### Submission on Swords to City Centre “Bus-Rapid-Transit” Proposals.

Cyclist.ie in collaboration with An Taisce and Dublin Cycling Campaign made a detailed submission on the NTA’s proposals to build a “Bus Rapid Transit” (BRT) line from Swords to the City Centre. (The NTA’s proposals can be seen here <http://www.nationaltransport.ie/consultations/public-consultation-on-swiftway-bus-rapid-transit-swordsairport-to-city-centre/>).

**Pearse Street showing proposed contra-flow cycle-lane (in purple) - see map 681**

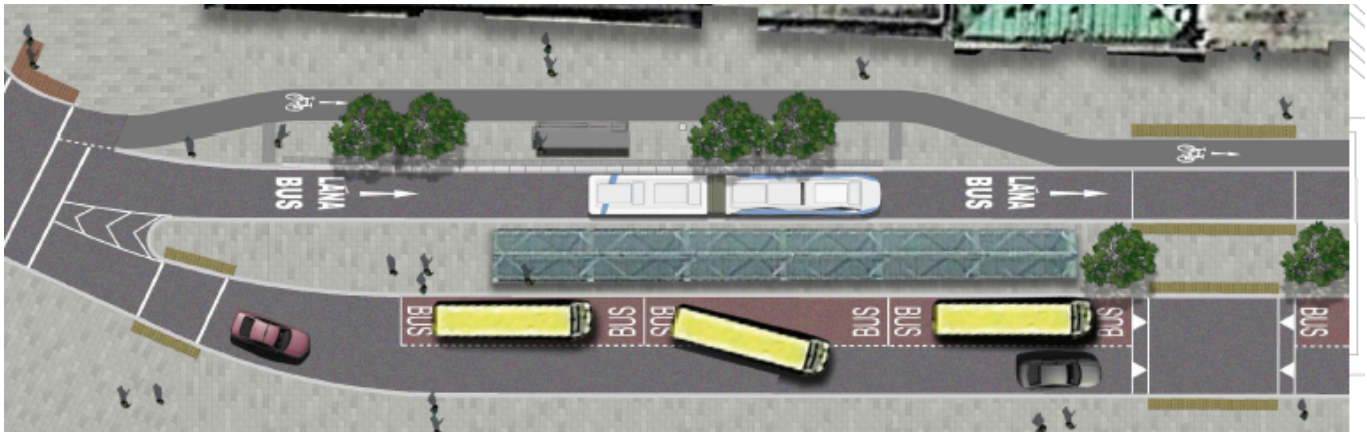
The proposals for the city centre parts of the line generally contain some very positive and progressive measures which should lead to some of the most cyclist-hostile junctions and one-way street (gyratory) systems being completely reconfigured. For example, we strongly endorse the proposal to have an eastbound contra-flow cycle lane on Pearse Street. However, linkages with adjacent streets and junctions need far more attention.
